UNITED STATES PATENT AND TRADEMARK OFFICE

10/800,080

Richard G. Campbell III

Office Action Summary	Application No.	Applicant(s)	
	10/800,080	CAMPBELL ET AL.	
	Examiner	Art Unit	
	Tho D. Ta	2833

Fig. 2

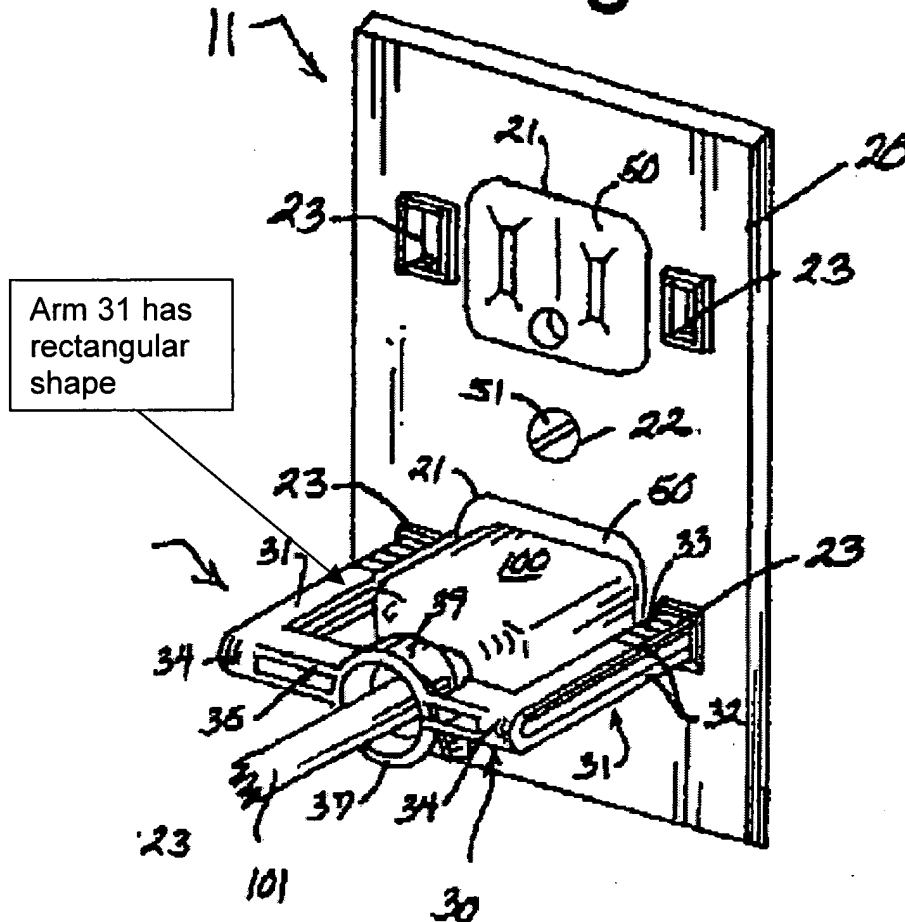
In regard to claim 14, McDevitt, Jr. discloses a method of retaining an electrical cord 101 in an electrical outlet 50, the method comprising: placing an electrical cord 101 through a slot (between 37 and 39) in a one piece plug retainer 30; inserting the plug 100 into an electrical outlet 50; pressing the plug retainer 30 into a replacement electrical outlet cover 11 until tabs 31 located on at least one side of the plug retainer 30 spread and lock into the replacement outlet cover 11.

In regard to claim 15, McDevitt, Jr. discloses that the removal of the plug retainer 30 from the electrical outlet cover 11 requires the user first press the plug retainer 30 into the electrical outlet cover 11 then depress at least one tab 31 before removing the plug retainer 30.

FIG. 1

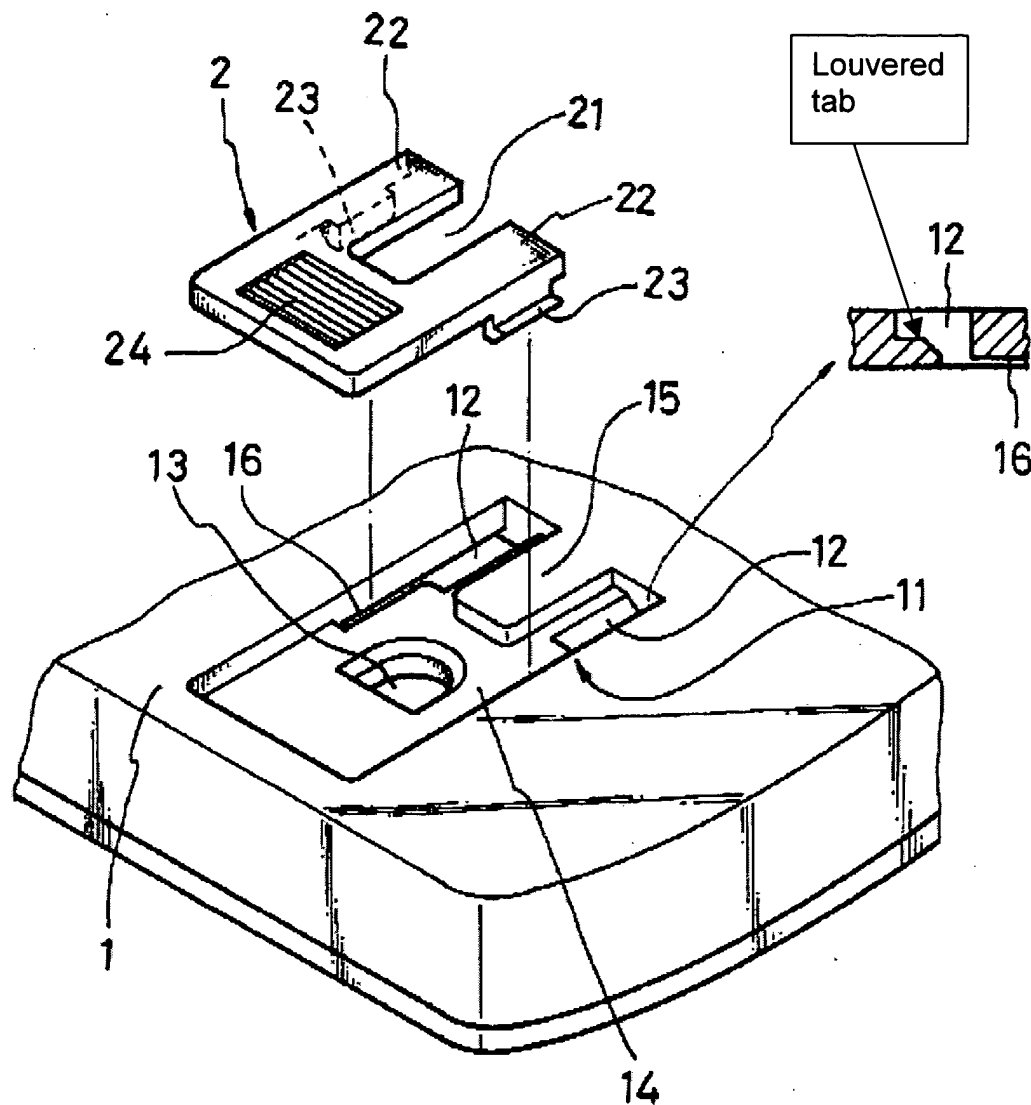
Chou discloses (in attached fig. 1) that the holes 12 in the outlet cover 1 includes a louver tab (see attached drawing) to prevent objects from being placed through the inside of the holes 12.

In response to applicant's argument that Chou does not disclose the louvered tab. Please see the attached drawing of Chou above. The louvered tab disclosed in

the above attached drawing would cover the hole once the tab 23 is engaged the hole 12.

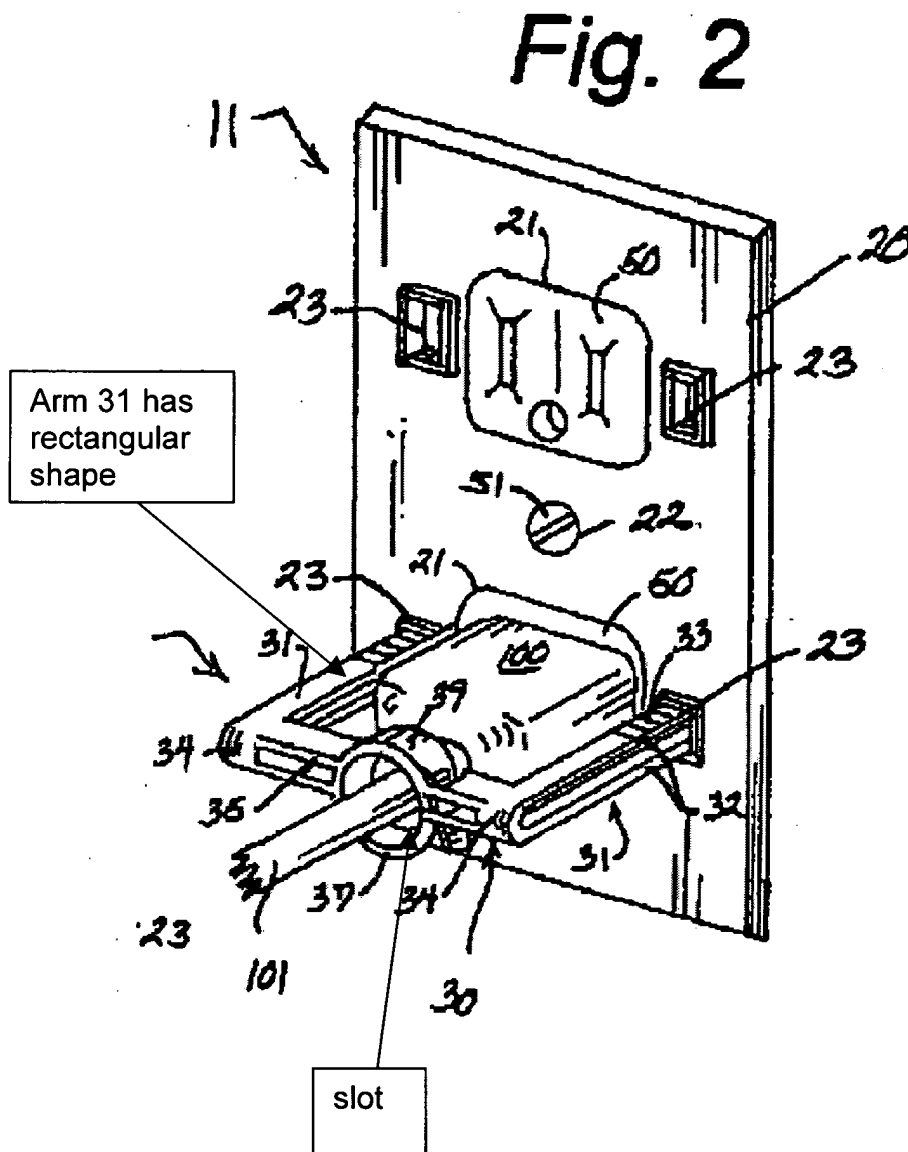
In regard to claim 1, McDevitt, Jr. discloses an electrical cord securing device comprising: a replacement outlet cover 11 configured with at least one hole located on opposite sides of an outlet; a substantially rectangular plug retainer 30 that surrounds at least a portion of an electrical cord 101 where the plug retainer 30 is installed in the replacement outlet cover 11 by pushing the plug retainer 30 into the replacement outlet cover 11 and removed by pressing in on the sides of the plug retainer to disengage the plug retainer from the outlet cover.

However, McDevitt, Jr. does not disclose that the holes 23, 33 in the replacement outlet cover 11 includes a louver tab to prevent objects from being placed through the inside of the holes 23, 33.

In regard to claim 4, McDevitt, Jr. discloses that the holes 23 are rectangular.

In regard to claim 5, McDevitt, Jr. discloses that a raised area 24 located on the back side of the holes 23 that require the user to press the plug retainer 30 into the outlet 50 before the power cord retaining device 30 can be removed.

In regard to claim 6, McDevitt, Jr. discloses that the plug retainer 30 has tabs 31 located on the sides of the plug retainer 30.

In regard to claim 7, McDevitt, Jr. discloses that the tabs 31 are rectangular (see attached drawing).

In regard to claim 8, McDevitt, Jr. discloses that the tabs 31 include detents 33 that require the user to press the sides of the plug retainer 30 down and inward to release the plug retainer 30 from the replacement outlet cover 11.
